Access Compliance Report

Public Rights-of-Way

Intersection ID: 50617	Main Street: GOLDEN_WOOD_LN	Cross Street: PADDLE_OAK_RD	Location: NW
ADA ID: 4CB6720B6083	Ramp Type: Perp	Initial Pass/Fail: Fail	Overall Compliance: No
		Severity Score: 12.5

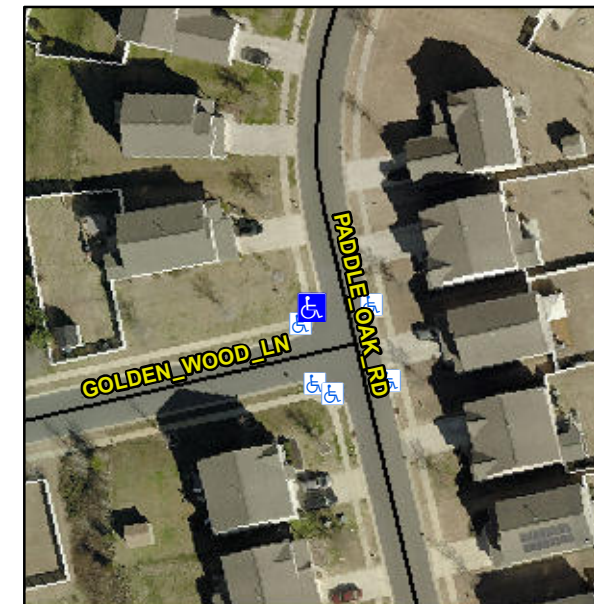
R304.2.2

Compliance	Description	Data	Compliance	Description	Data
N/A	Ramp Length (in)	48.0	No	Ramp Slope (%)	10.6
Yes	Ramp Width (in)	48.0	Yes	Ramp XSlope (%)	1.1
N/A	Flare Type LT	N/A	N/A	Flare Type RT	N/A
N/A	Flare Slope LT (%)	N/A	N/A	Flare Slope RT (%)	N/A
N/A	Flare Traversable LT?	N/A	N/A	Flare Traversable RT?	N/A
N/A	Landing Length (in)	N/A	N/A	DWS Provided?	N/A
N/A	Landing Width (in)	N/A	N/A	DWS Contrast?	N/A
N/A	Landing Slope (%)	N/A	N/A	DWS Length (in)	N/A
N/A	Landing X Slope (%)	N/A	N/A	DWS Full Width?	N/A
N/A	Landing Curb? (Y/N)	N/A	N/A	DWS Offset (in)	N/A
N/A	Shared Landing?	N/A			
N/A	Gutter Ponding?	N/A	N/A	Gutter Slope (%)	N/A
N/A	Gutter Lip Ht (in)	N/A	N/A	Gutter X Slope (%)	N/A
N/A	Painted X Walk1?	No	N/A	Painted X Walk2?	N/A
	X Walk 1 Direction	To E		X Walk 2 Direction	N/A
N/A	X Walk 1 Width (in)	N/A	N/A	X Walk 2 Width (in)	N/A
	X Walk 1 Slope (%)	2.3		X Walk 2 Slope (%)	N/A
	X Walk 1 X Slope (%)	3.0		X Walk 2 X Slope (%)	N/A

Remove & Replace Entire Ramp.
